**KNOXVILLE HISTORIC ZONING COMMISSION
STAFF REPORT - CERTIFICATE OF APPROPRIATENESS APPLICATION**

PROPERTY ADDRESS: 605 Caswell St 37917

FILE NO.: 9-O-17-HZ

MEETING DATE: 10/19/2017

ATTACHMENT

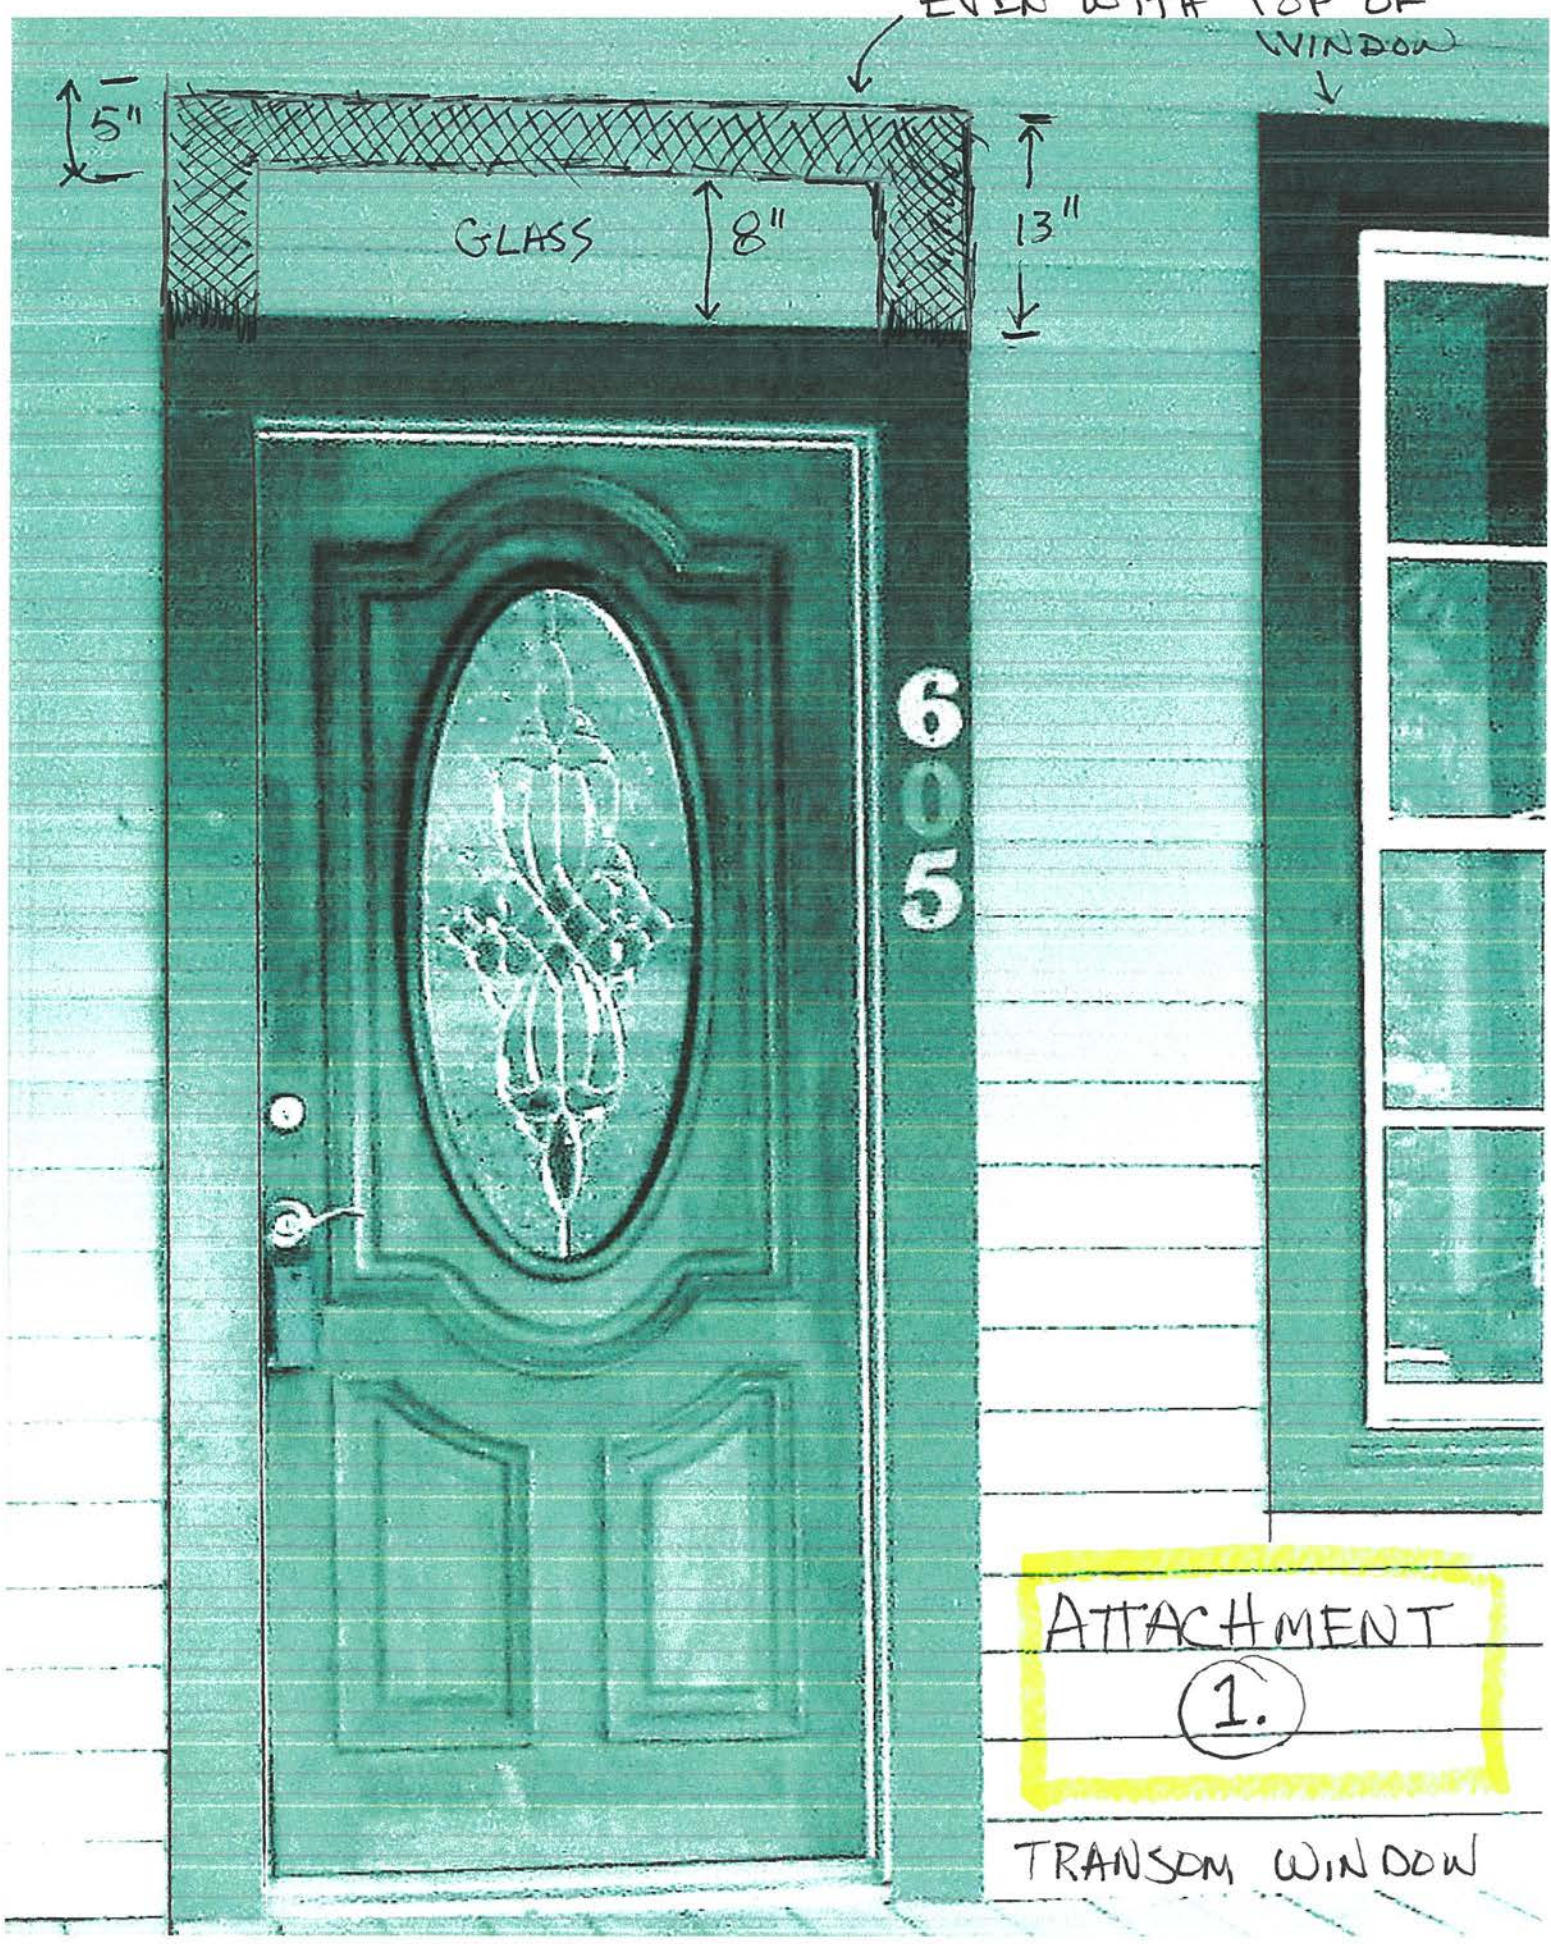
1. There is physical evidence on the house in its change of siding type and window height to indicate that a transom existed over the entry door, and this is a very typical and common characteristic by the current configuration and not proportionate to the house.

Approval with the condition that the proposed baluster-spacing of 1-3/4 inches be checked for historic appropriateness.

605 Caswell Ave - HZC application for CA 10/19/17
Attachment 2 - side yard / Luttrell

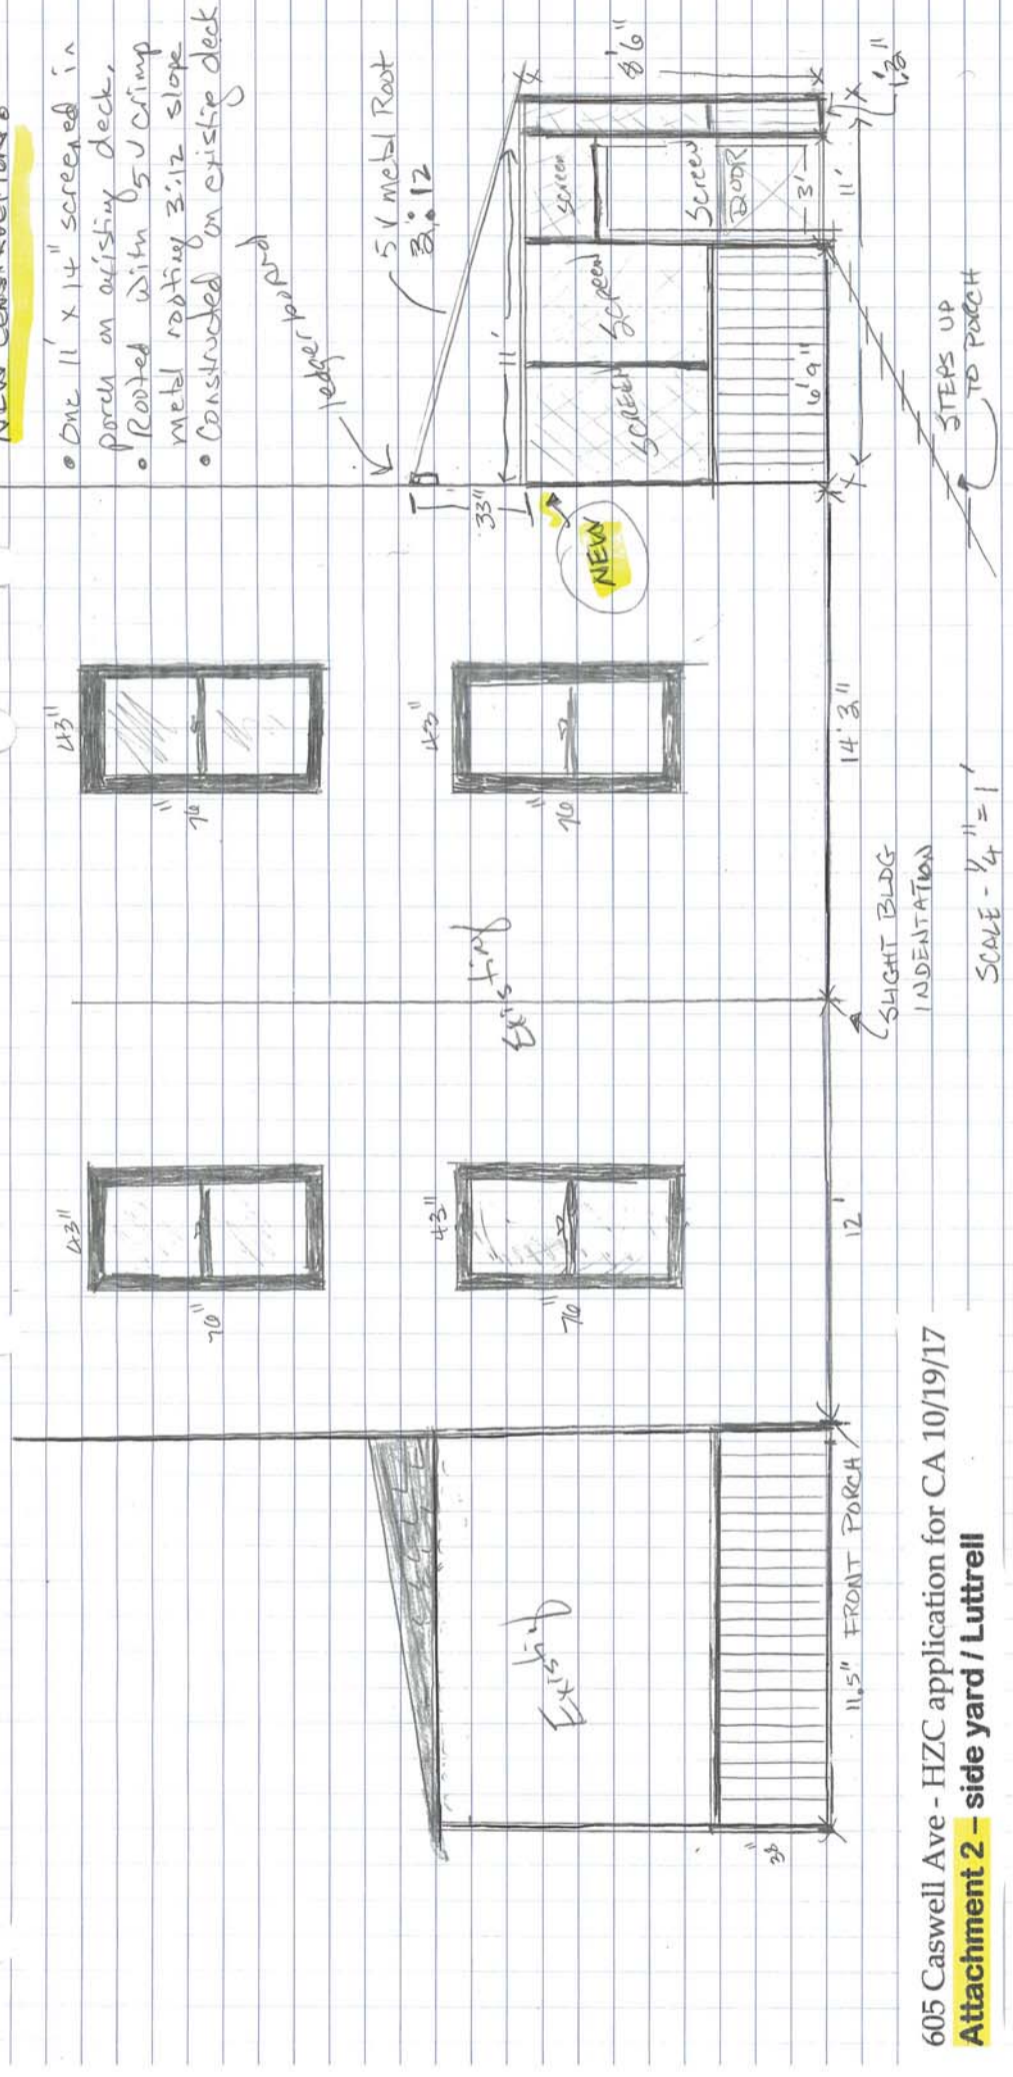
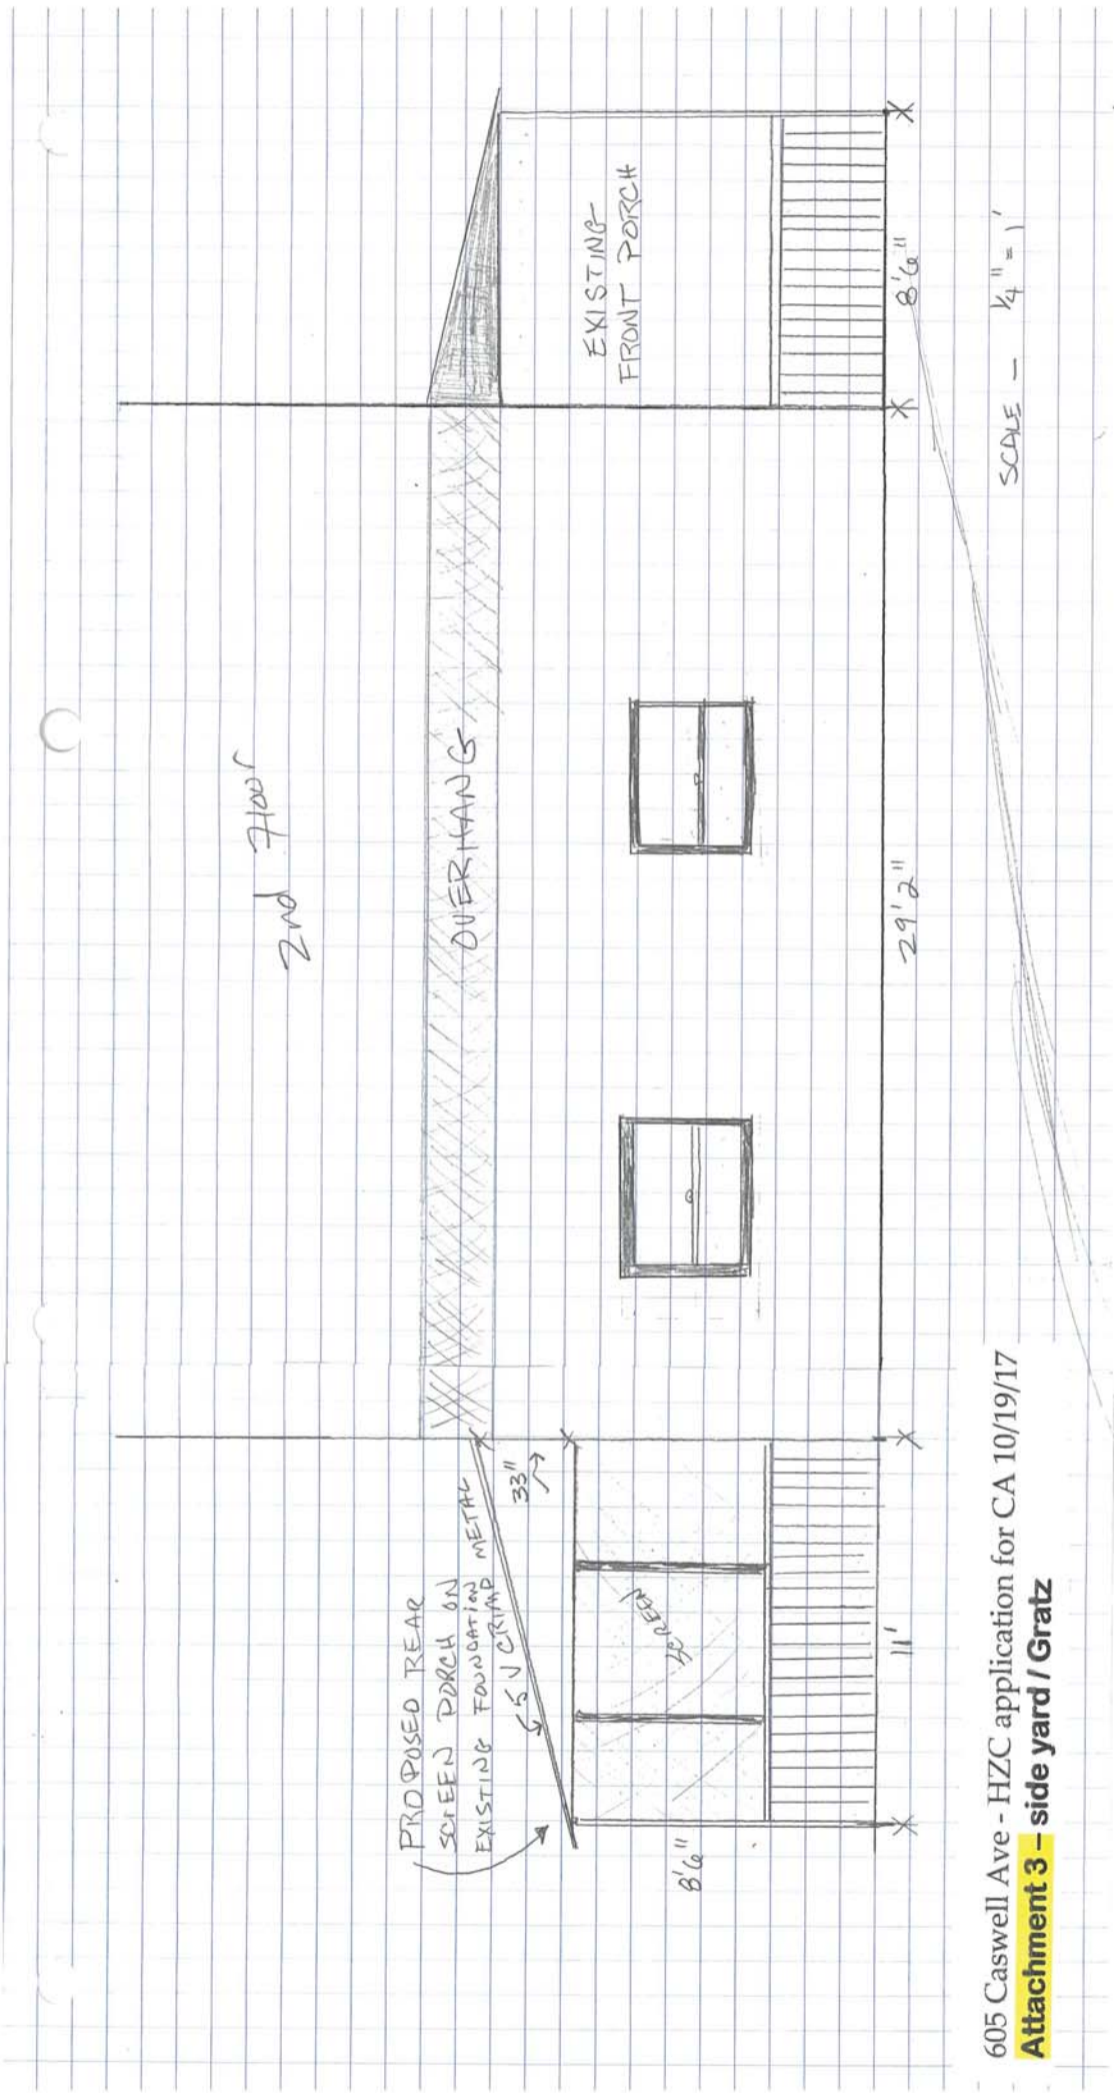
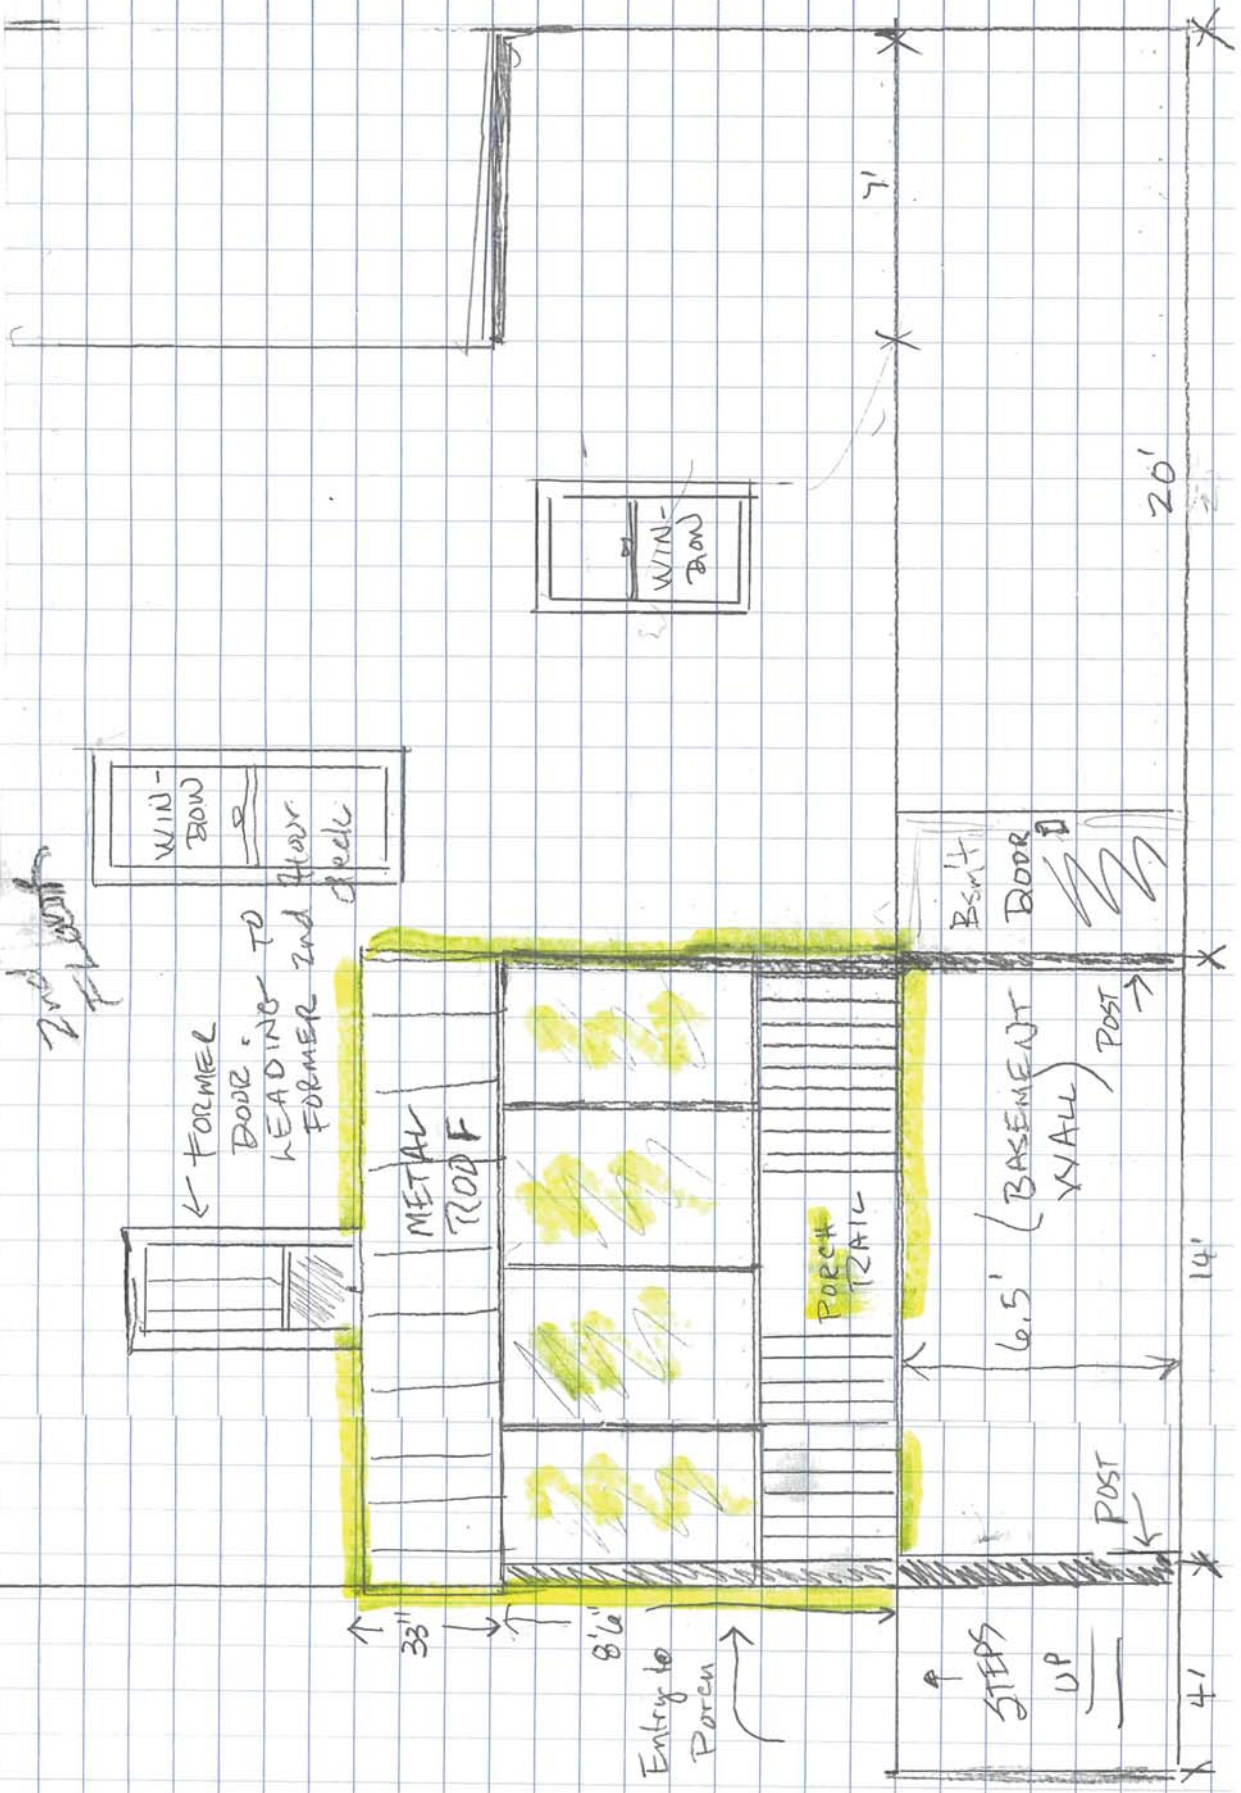
2. The screened-in porch on the rear elevation will not be seen from the front street right-of-way and will not destroy historic fabric. The late wooden deck and steps that were removed were not of historical importance. The 5 V-groove metal roofing, while not appropriate on a historic front porch, is not inappropriate on a rear porch.
